Docket Item # 2 & 3
BAR CASE # 2015-0002 &
2015-0004

BAR Meeting
February 4, 2015

ISSUE: Permit to Demolish and Certificate of Appropriateness
for Alterations

LOCATION: 724 South Royal Street

Figure 2: c1940s Yates Gardens Interior Photo of a Bay Window

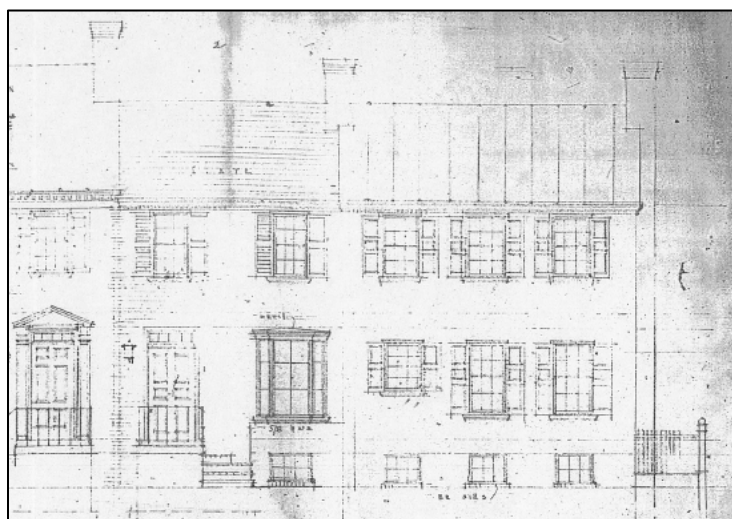
Regarding the proposed alterations to the existing building, staff supports the installation of a new window on the front elevation based on the above photo documentation, which identifies that bay windows of very similar configurations were an original design option provided by the architect for townhouses throughout the development. Staff finds that, since this was a design

element used on these buildings during the first period of construction, and the applicant's design is very similar to the architect's original renderings, the proposed bay window is not a conjectural feature but architecturally appropriate, yet subtly differentiated. Therefore, staff recommends approval of the Certificate of Appropriateness, with the general condition that the applicant must submit detailed window specifications for the aluminum-clad wood windows which comply with the Board's *Window Performance Specifications*.

PROPOSED
BAY WINDOW

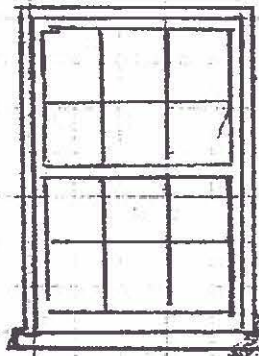
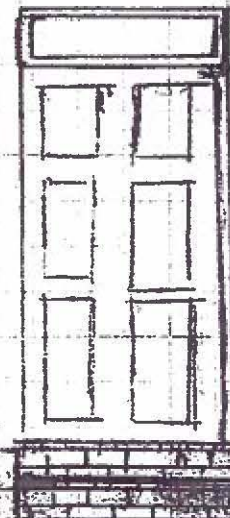
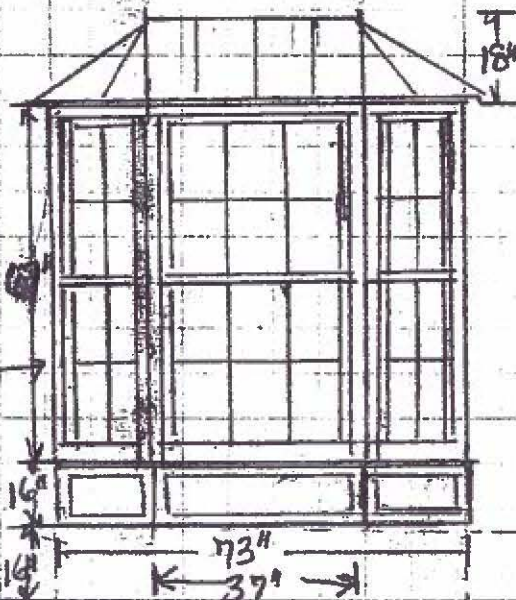
C-1 Zoning compliance cannot be determined. Applicant must submit open space and FAR calculations for bay window bump out.

- That the aluminum clad wood windows proposed on the addition are consistent with the *Window Performance Specifications* – including putty profile muntins.
- That BAR approval is subject to compliance with the Zoning Ordinance. Applicant must submit FAR and open space calculations for bay window bump-out for zoning approval prior to the release of Building Permits.
